**RFI 098
Pebble Project EIS**

Title/Subject:	TSF Options, Mine Area
Requestor:	AECOM
Date Transmitted:	10/16/2018
Recipient:	Pebble Limited Partnership (PLP)
Response Requested by:	10/22/2018
Rationale:	The PLP response for RFI 069 presented 26 potential TSF locations that were considered near the mine area. Details on feasibility and environmental considerations for these locations are necessary for alternatives screening purposes and for the USACE to evaluate the Least Environmentally Damaging Practicable Alternative (LEPDA).
Describe the Information Requested and Level of Detail:	<p>Please provide an evaluation of each mine area TSF location that was considered and explain why the NFK West and NFK East locations were ultimately selected. Include:</p> <ul style="list-style-type: none"> • Feasibility (technology, economics, logistics, common sense) • Availability (both now and ten years ago during project planning) • Environmental impacts (wetlands/Waters of the US, miles of streams, habitat, fill, dam safety, etc.)

The question presented in RFI 098 on TSF options in the mine area is addressed below:

TSF OPTION 21

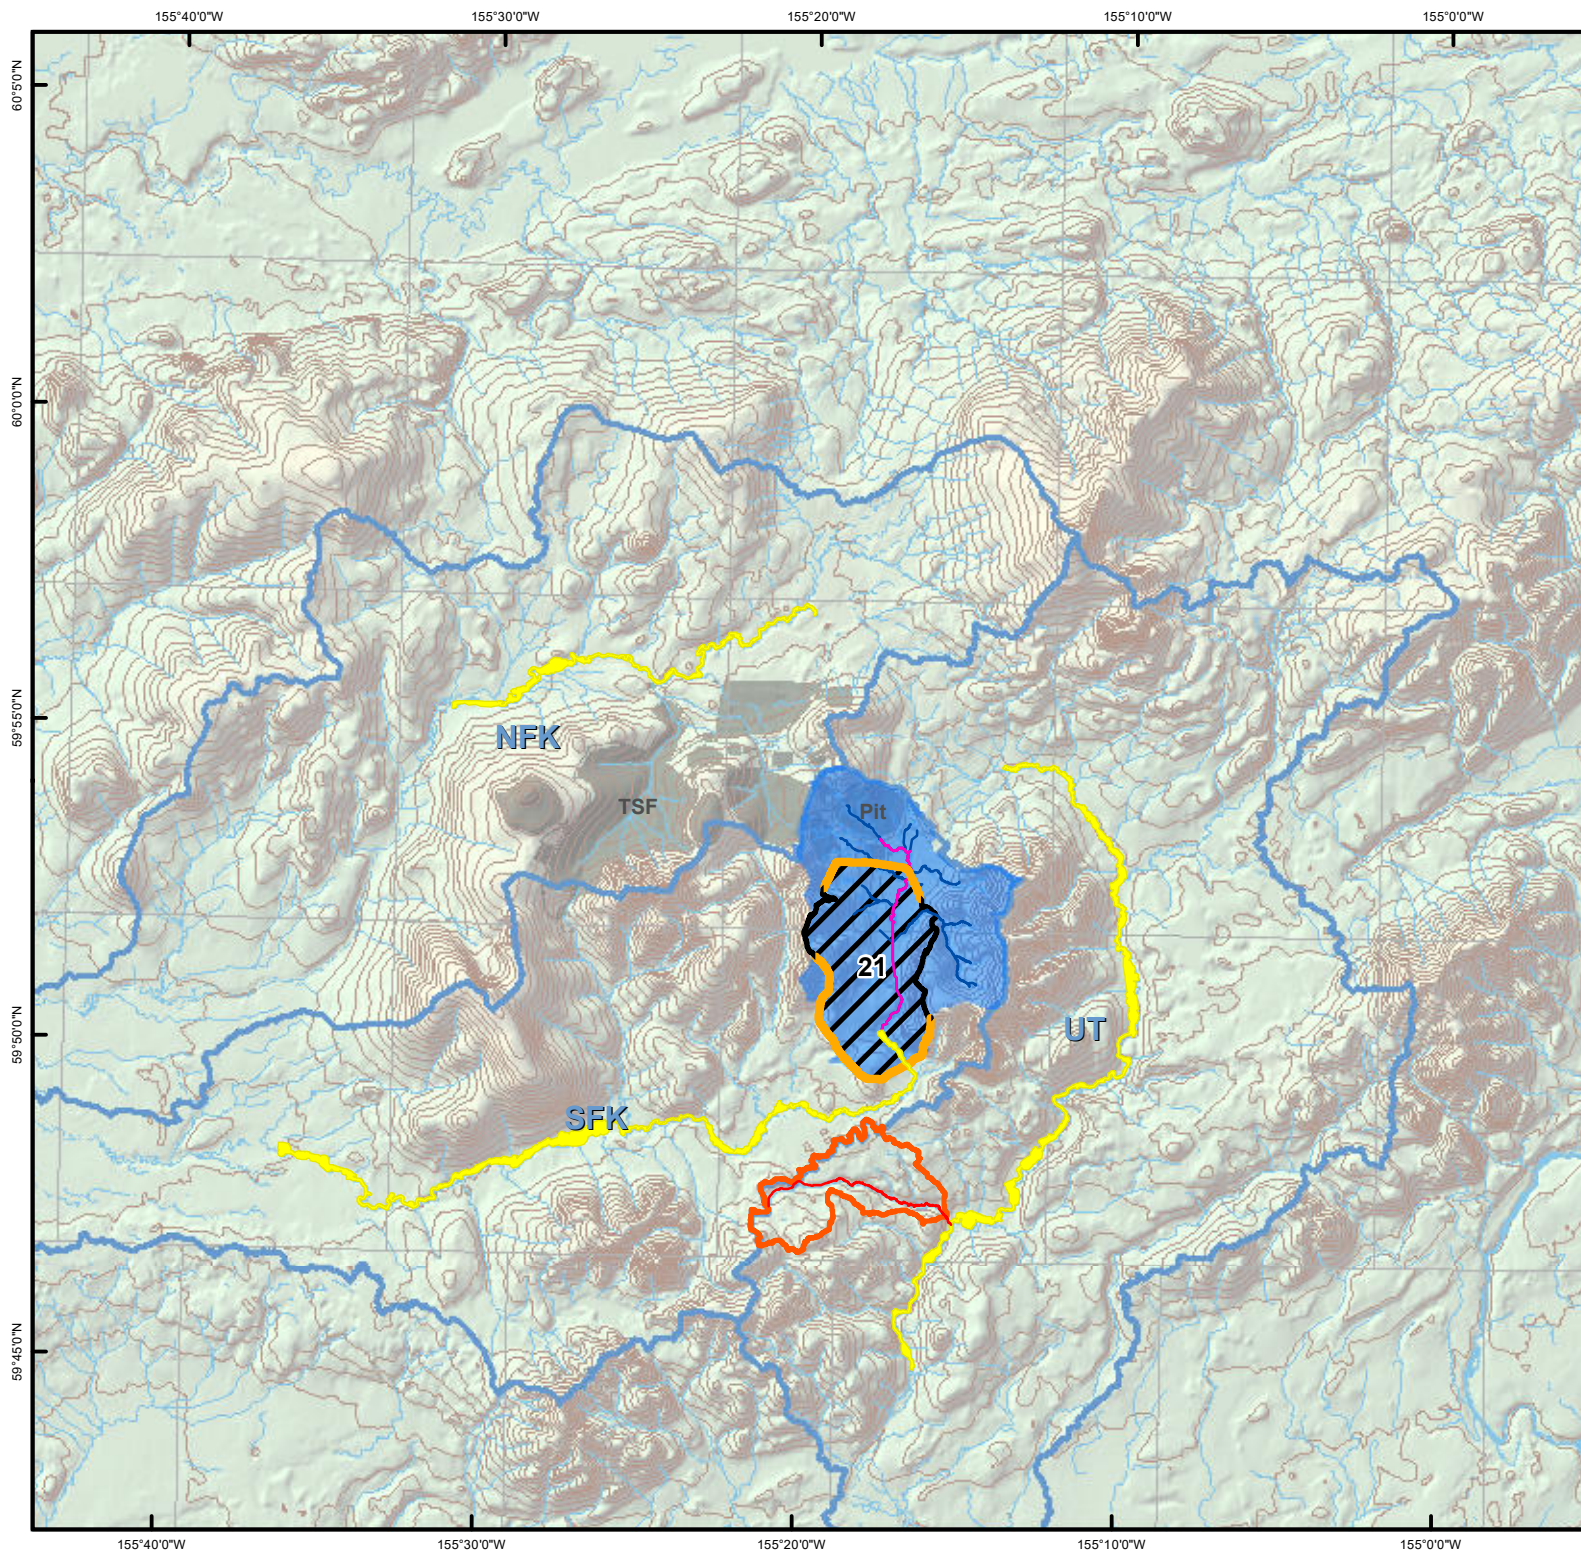
Option 21

- Fills less mapped wetlands but has a larger overall footprint and similar stream impacts.
- Impacts to fish-bearing and anadromous streams are higher.
- Embankment location precludes effective collection of seepage from a flow-through embankment and would have the potential to impact groundwater flows into the SFK and UTC 119A drainages.
- The footprint encroaches on MCO393.
- The facility as reported is larger than required to store 1250 million tons of tailings, but this could be adjusted by dropping the embankment height, which would not significantly change the reported impacts.

TSF OPTION 22

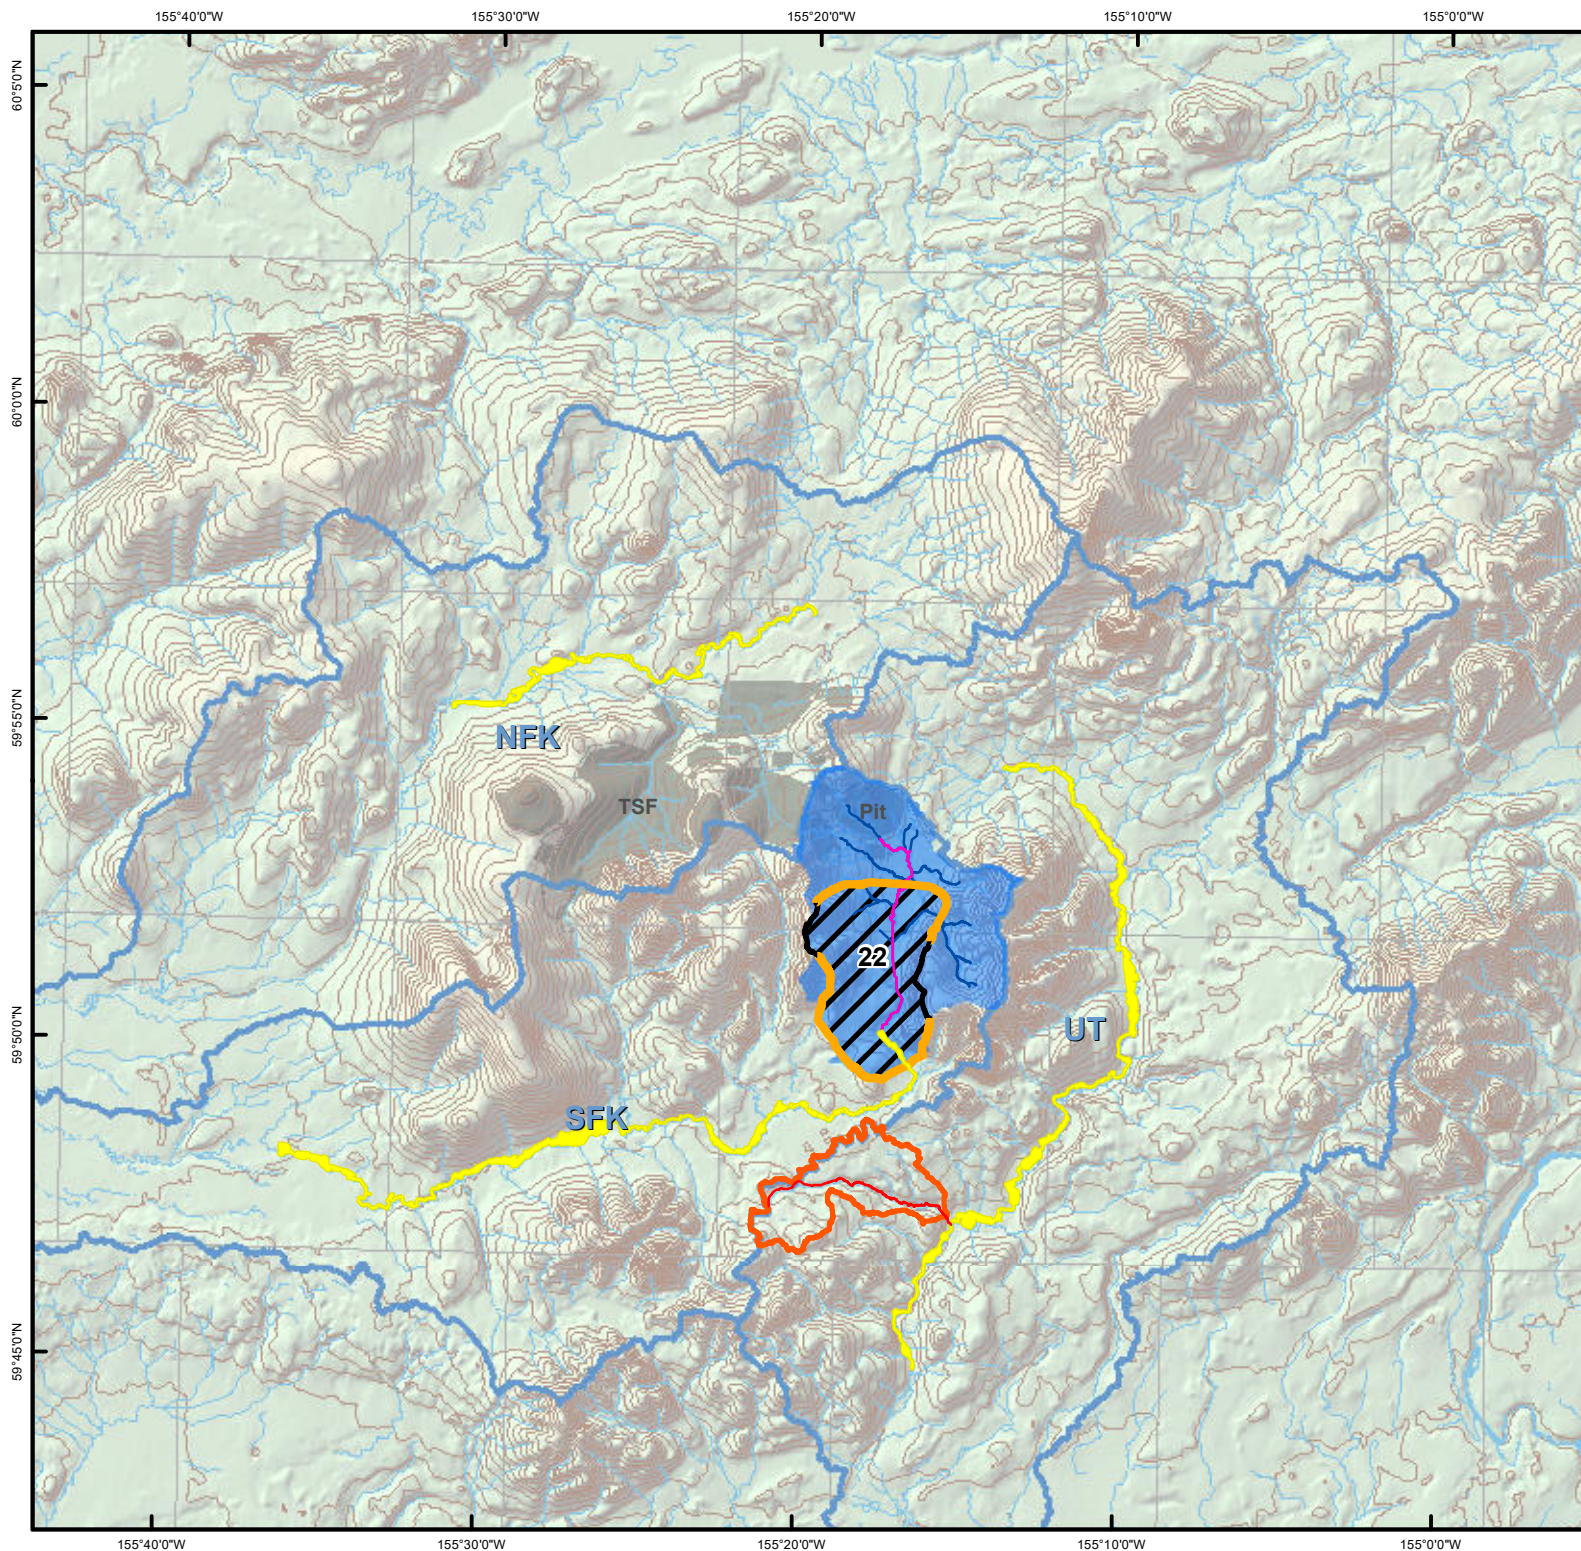
Option 22

- Fills less mapped wetlands but has a larger overall footprint and similar stream impacts.
- Impacts to fish-bearing and anadromous streams are higher.
- Embankment location precludes effective collection of seepage from a flow-through embankment and would have the potential to impact groundwater flows into the SFK and UTC 119A drainages.
- The footprint encroaches on MCO393.
- The facility as reported is larger than required to store 1250 million tons of tailings, but this could be adjusted by dropping the embankment height, which would not significantly change the reported impacts.

TSF OPTION 23

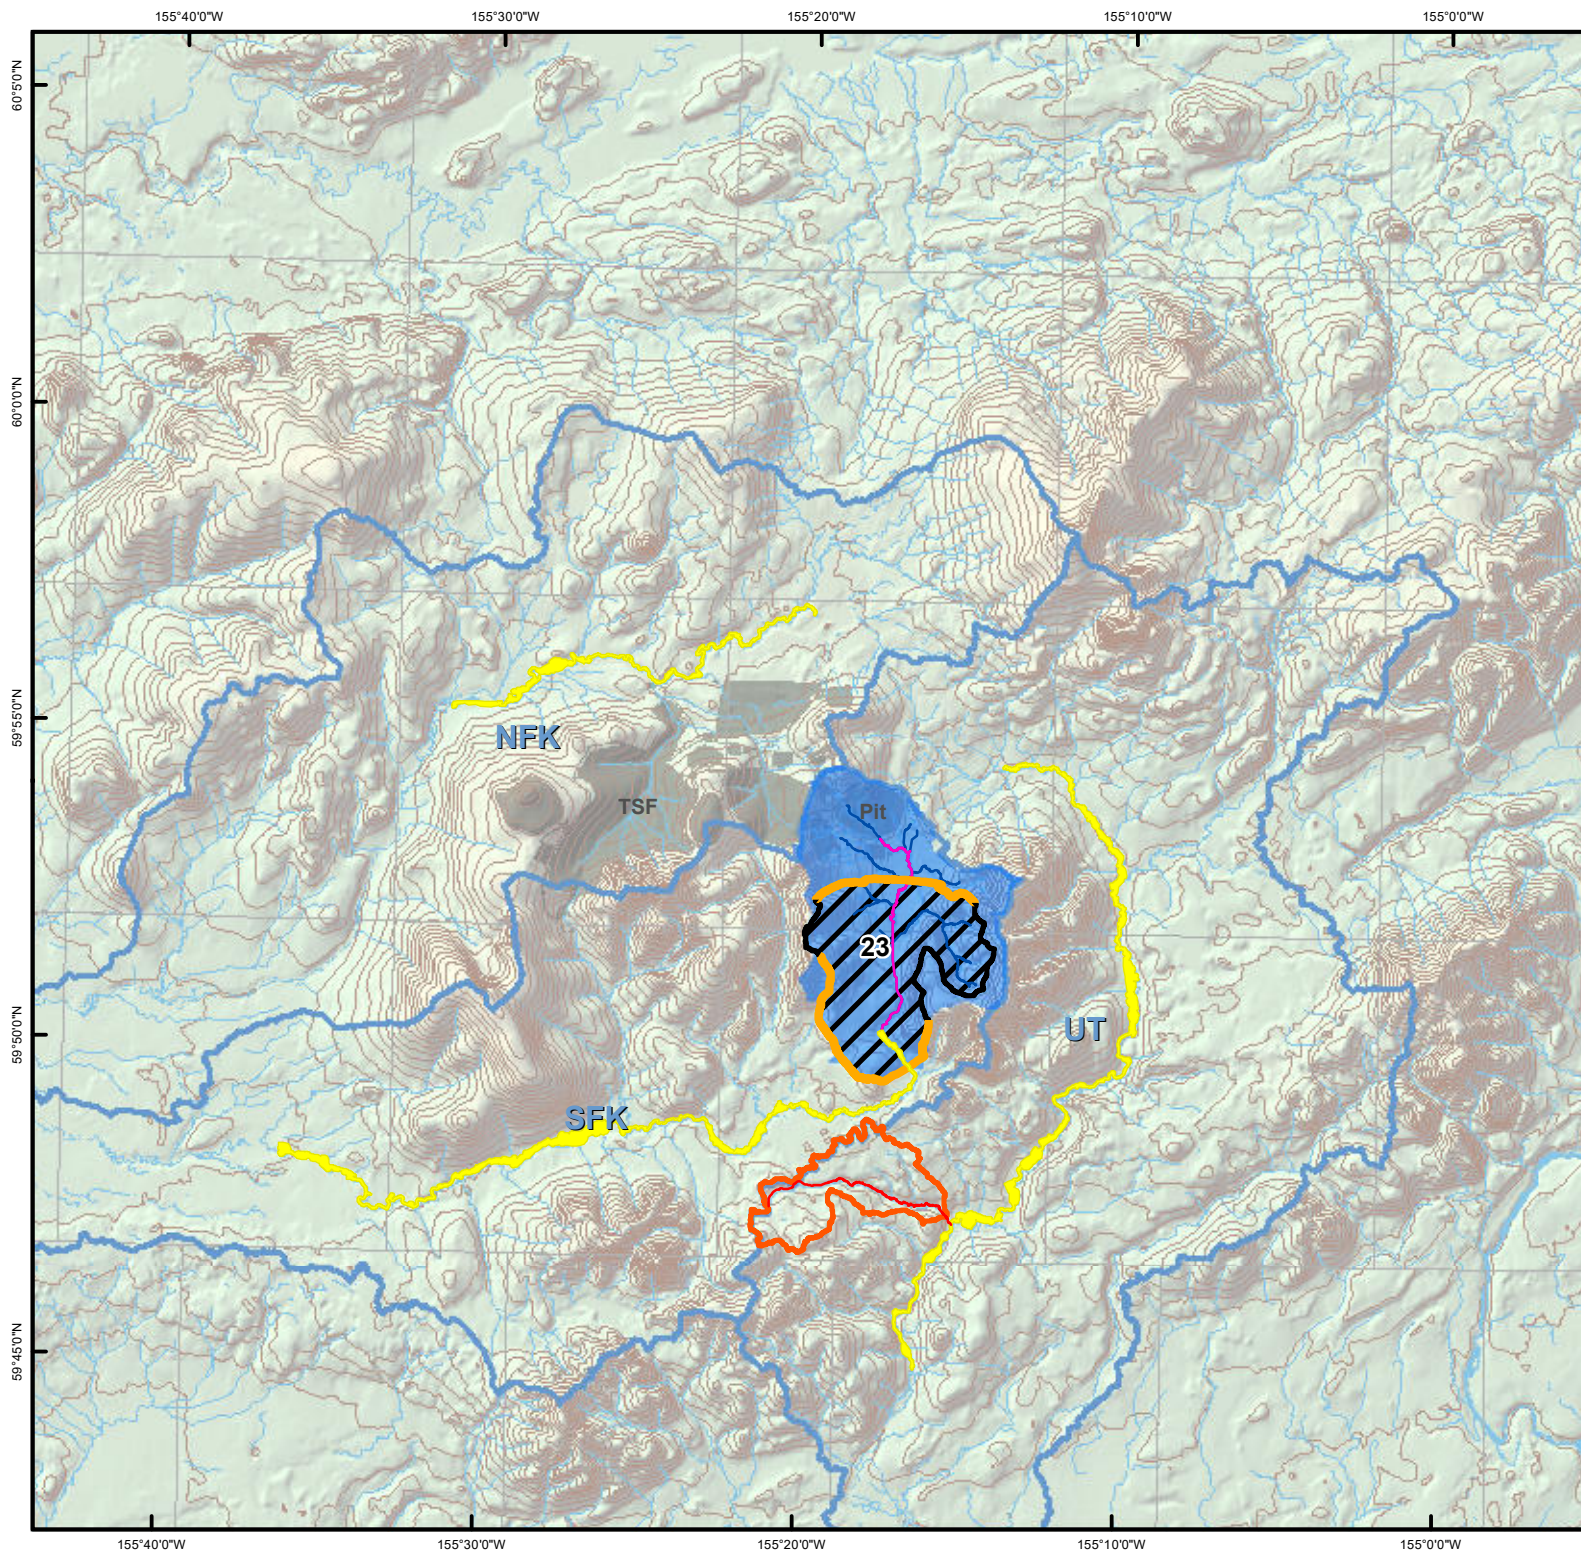
Option 23

- Fills less mapped wetlands but has a larger overall footprint and similar stream impacts.
- Impacts to fish-bearing and anadromous streams are higher.
- Embankment location precludes effective collection of seepage from a flow-through embankment and would have the potential to impact groundwater flows into the SFK and UTC 119A drainages.
- The footprint encroaches on MCO393.
- The facility as reported is larger than required to store 1250 million tons of tailings, but this would be adjusted by dropping the embankment height, which would not significantly change the reported impacts.

TSF OPTION 24

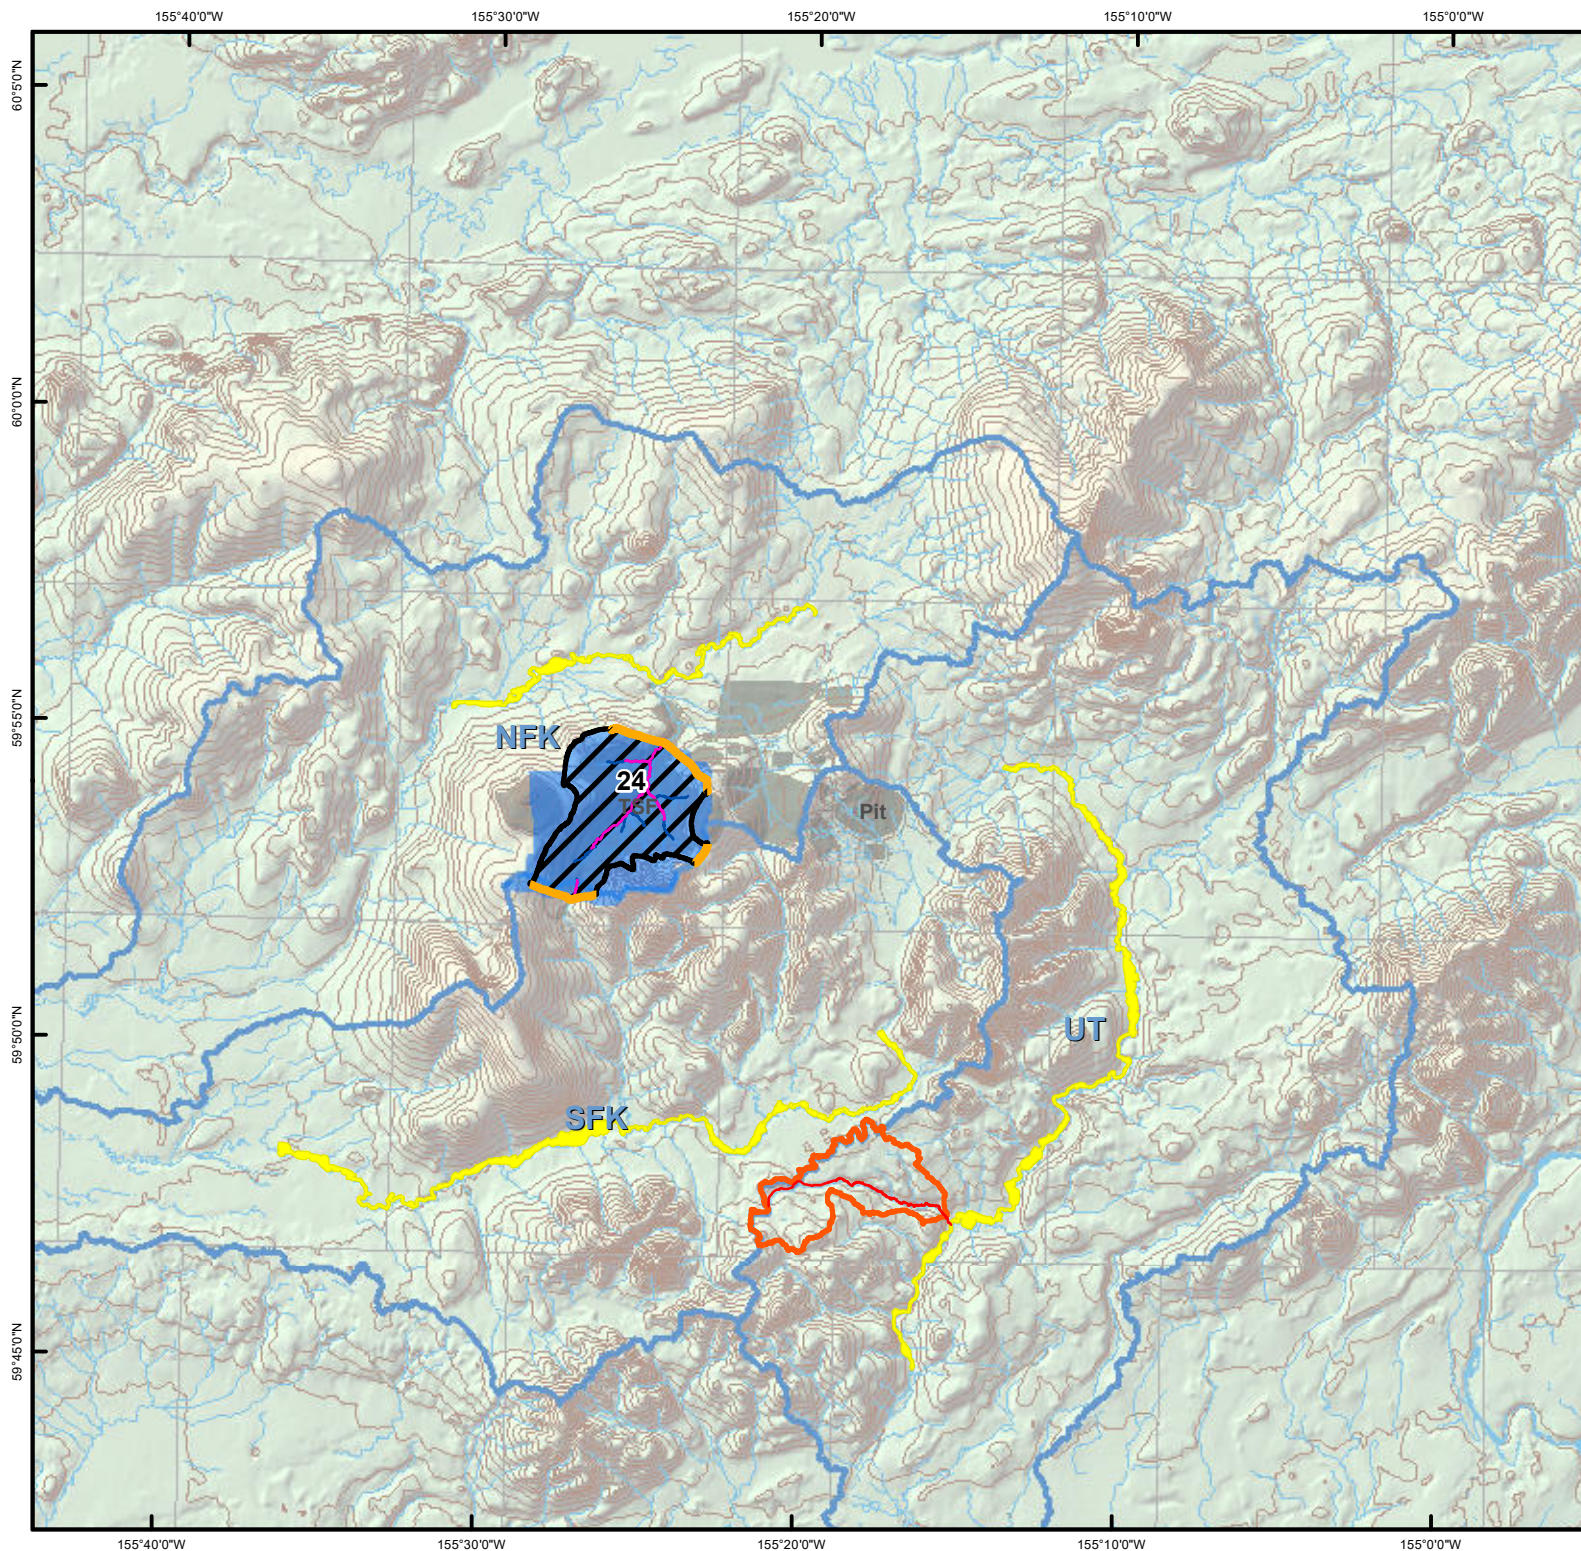
Option 24

- This option corresponds to Layout Option 1 for the Proposed Project and is broadly similar in measured impacts to the updated proposed project.
- This option was not selected as Layout Option 3 provided for improved long-term post closure management of the tailings and improved long-term post closure dam safety.
